Metro Inner Development Assessment Panel Agenda

1. Declarations of Due Consideration
2. Disclosure of Interests
3. Form 1 DAP Applications
 - 3.1 117-119 (Lots 207 & 206) Lockhart Street, Como - 14 Grouped Dwellings – DAP/24/02645
4. Form 2 DAP Applications
5. Section 31 SAT Reconsiderations

DAP Name:	Metro Inner Development Assessment Panel
Local Government Area:	City of South Perth
Applicant:	Urbanista Town Planning
Owner:	Olivii Pty Ltd
Value of Development:	\$7.7 million
Responsible Authority:	City of South Perth
Authorising Officer:	Fiona Mullen, Manager Development Services Scott van Ierland, Senior Urban Planner
LG Reference:	PDDA-2023/2055
DAP File No:	DAP/2024/02645
Application Received Date:	31 January 2024
Report Due Date:	9 August 2024
Application Statutory Process Timeframe:	90 Days
Attachment(s):	1. Aerial Image and Zoning Map 2. Schedule of Submissions 3. Design Review Panel Minutes 4. Solar Access Diagrams 5. Development Plans 6. Environmentally Sustainable Design Report 7. Waste Management Plan 8. Traffic Impact Statement 9. Acoustic Report 10. Section Drawings

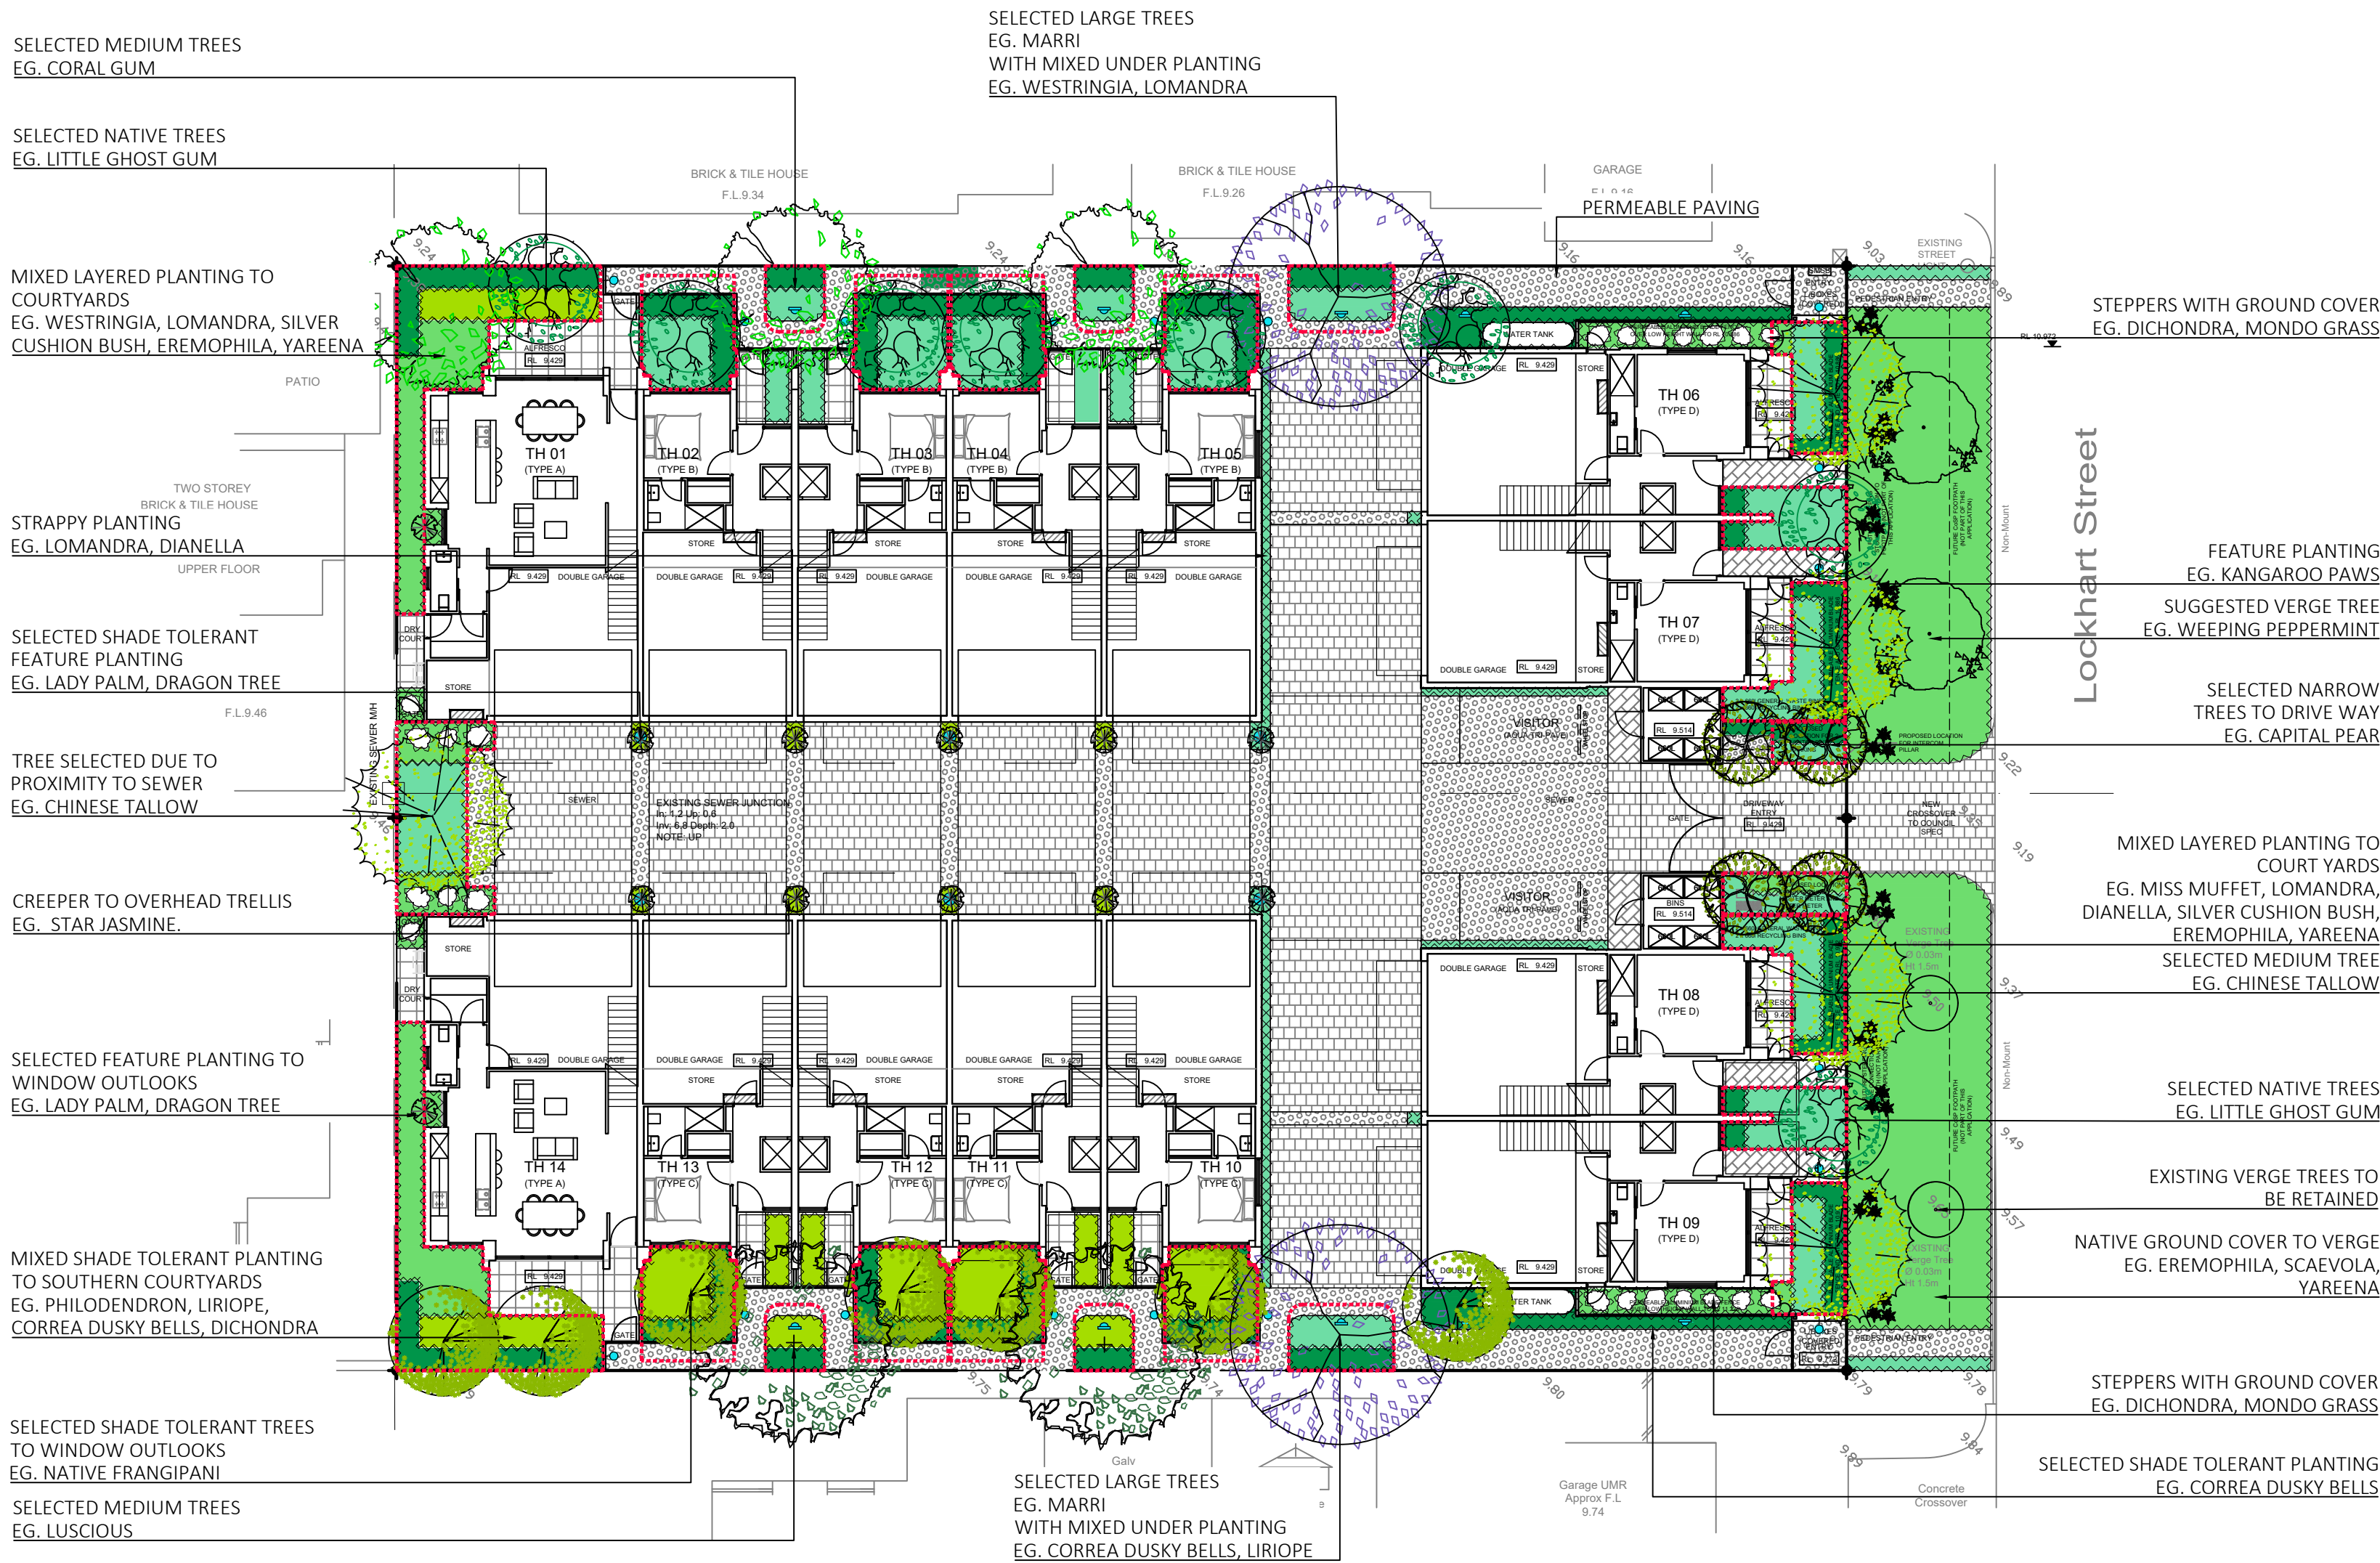
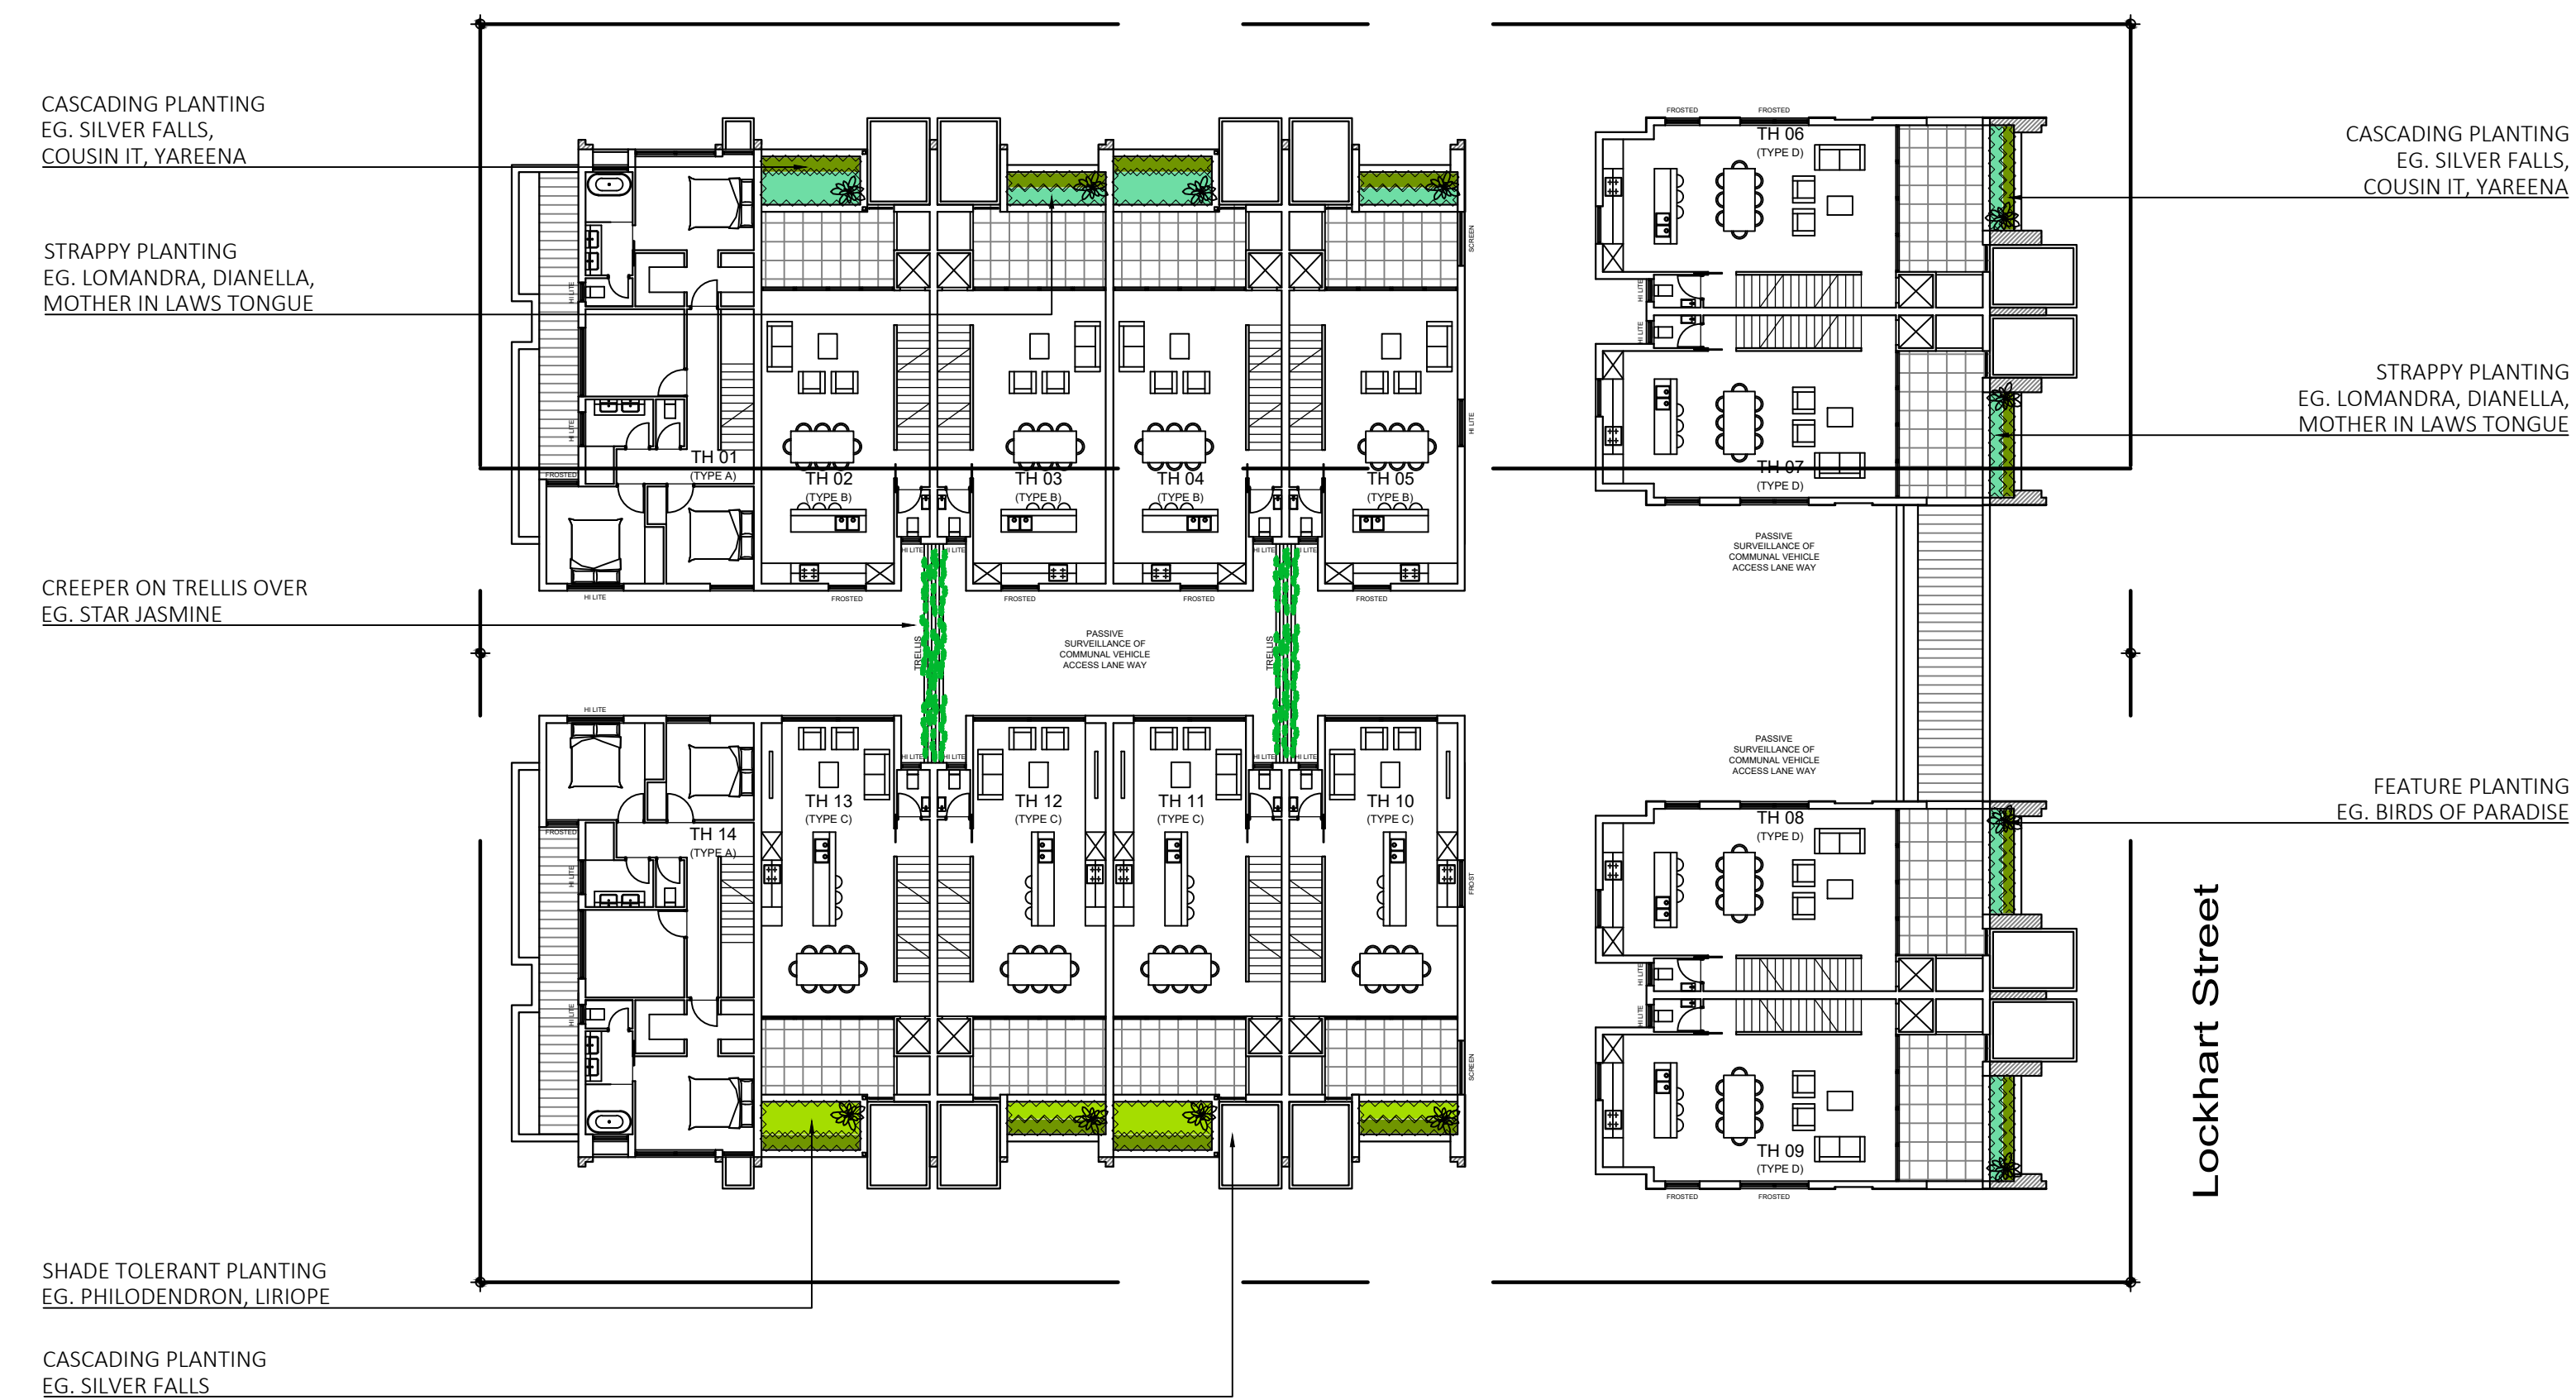
Approximately 40% of the tree canopy is illustrated as extending beyond the boundary of the site raising concerns about the long-term viability of landscaping.	No changes to tree planting location provided.
The provided ESD consultant report is not sufficient in scope or commitment for the development.	An amended ESD report has been provided.

The development is required to provide 75% of the parent lot area as landscaping, inclusive of balconies with an area of 12.0m² or greater. The development proposes to provide 22% of the parent lot as landscaping, resulting in a landscaping shortfall of 686m².

The submitted landscaping plan indicates approximately 40% of the proposed tree canopy coverage proposed is located outside of the site boundaries, overhanging adjoining lots. A copy of the landscaping plans can be found at **Attachment 5** within the Development Plans.
